To: Kristopher Byrd, Well Construction and Compliance Section Manager
From: Travis Kelly, Well Construction Compliance Coordinator
Subject: Review of Water Right Application G-19048
Date: February 10, 2022

Application # G- 19048

PUBLIC INTEREST REVIEW FOR GROUNDWATER APPLICATIONS

D1. Well #: 1, 2 Logid: CLAC 12533, N/A (proposed)

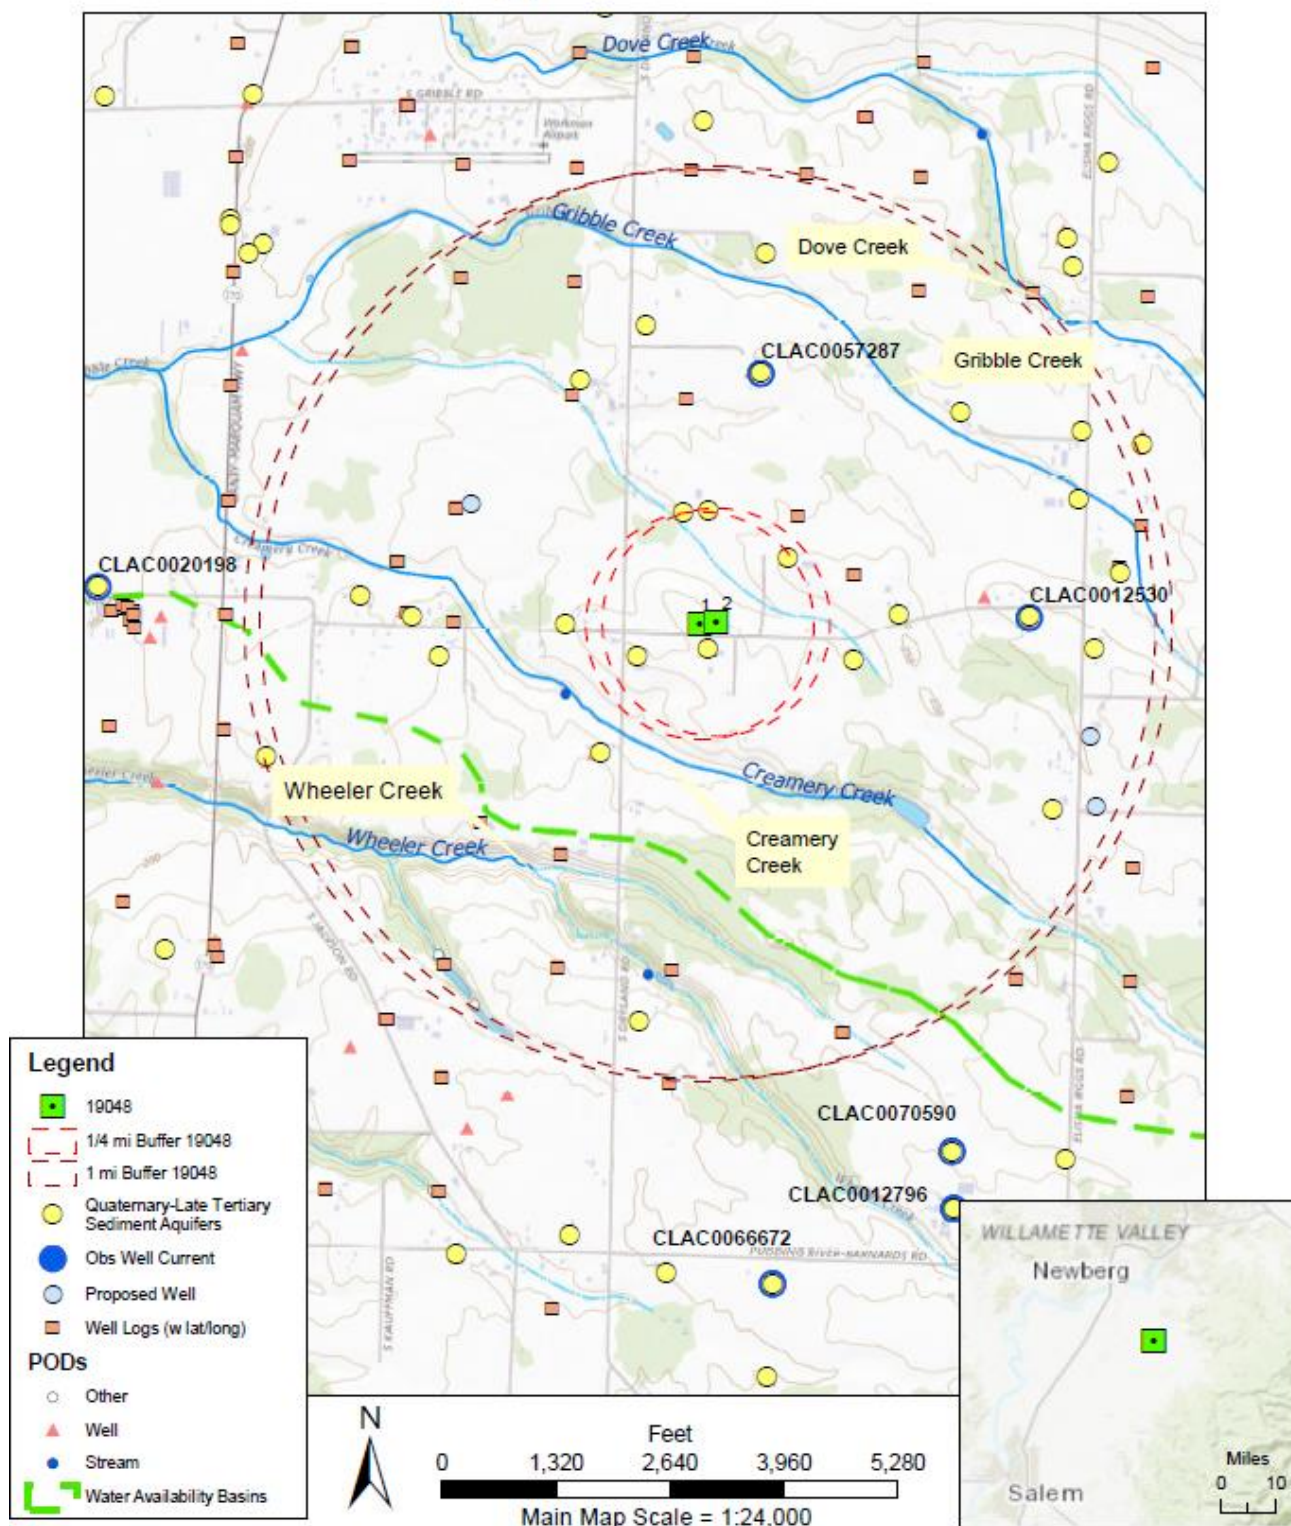
Applicant's Well #1 (CLAC 12533): Based on a review of the Well Report, Applicant's Well #1 does not appear to comply with current minimum well construction standards (See OAR 690 Division 210). The problem is that the Water Supply Well Report indicates that the well head is flush with land surface. In addition, the well report indicates that the well is sealed with "puddled clay." This is not an approved sealing material. In order to meet minimum well construction standards, the well head must be extended so that it is at least one-foot above land surface, and the well must be re-sealed with an approved sealing material.

Applicant's Well #2 (Proposed Well): Applicant's Well #2 is a proposed well, therefore it cannot be reviewed for construction. Construction of this proposed well shall be completed in a manner that protects ground water resources as required under Oregon Administrative Rules 690-200 through 690-240. During construction of this well, specific attention should be paid to ensure sealing requirements are met and that the well does not commingle aquifers.
